Access Compliance Report Public Rights-of-Way (Curb Ramps)

Main Street: KYLE_CT Cross Street: KYLE_CT Location: S

ADA ID: RPRK211021161142 Ramp Type: Type 4 - Parallel Initial Pass/Fail: Fail Overall Compliance: No Severity Score: 2

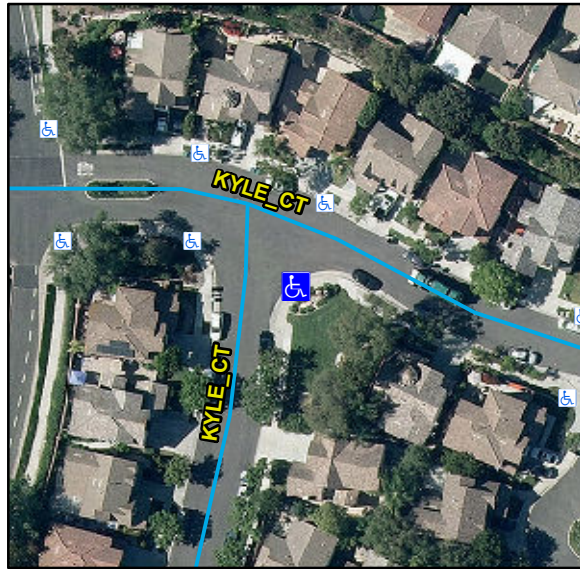
Compliance	Description	Data	Compliance	Description	Data
N/A	Ramp Length LT (in)	110	N/A	Ramp Length RT (in)	118
Yes	Ramp Width LT (in)	54	Yes	Ramp Width RT (in)	53
Yes	Ramp Run Slope LT (%)	7.3	Yes	Ramp Run Slope RT (%)	3.6
No	Ramp Cross Slope LT (%)	2.8	No	Ramp Cross Slope RT (%)	2.2
N/A	Landing Present	N/A	N/A	DWS Provided	N/A
N/A	Landing Length (in)	N/A	N/A	DWS Contrast	N/A
N/A	Landing Width (in)	N/A	N/A	DWS Length (in)	N/A
N/A	Landing Run Slope (%)	N/A	N/A	DWS Full Width	N/A
N/A	Landing Cross Slope (%)	N/A		DWS Offset Type	N/A
N/A	Landing Movement Obstructed?	N/A	N/A	DWS Offset Left (in)	N/A
	Landing Movement Type	N/A	N/A	DWS Offset Right (in)	N/A
N/A	Landing Shared	N/A			
N/A	Clear Space	Yes			
N/A	Clear Space To Crosswalk (in)	N/A			
N/A	Marked Crosswalk 1	No	N/A	Marked Crosswalk 2	No
	Crossing 1 Direction	NE		Crossing 2 Direction	NW
	Marked Crosswalk 1 Width (in)	N/A		Marked Crosswalk 2 Width (in)	N/A

N/A	Ramp Inside Crosswalk 1	N/A	N/A	Ramp Inside Crosswalk 2	N/A
	Crossing 1 Slope (%)	0.2		Crossing 2 Slope (%)	2
	Crossing 1 Cross Slope (%)	2.6		Crossing 2 Cross Slope (%)	1.7
N/A	Gutter Ponding	N/A	N/A	Curb Slope	16.9
Yes	Gutter Lip Height (in)	0		Road Run Slope (%)	3.1
N/A	Gutter Run Slope (%)	N/A		Road Cross Slope (%)	2.7
N/A	Gutter Cross Slope (%)	N/A	No	Perpendicular Joint Present	No
Yes	Overall Surface Condition	Acceptable			
	Cross Gutter Present?	No		Spandrel Present?	No
	Replace Cross Gutter?	N/A		Replace Spandrel?	N/A

Remove & Replace Curb Ramp With Two New Directional Ramps or Equivalent.
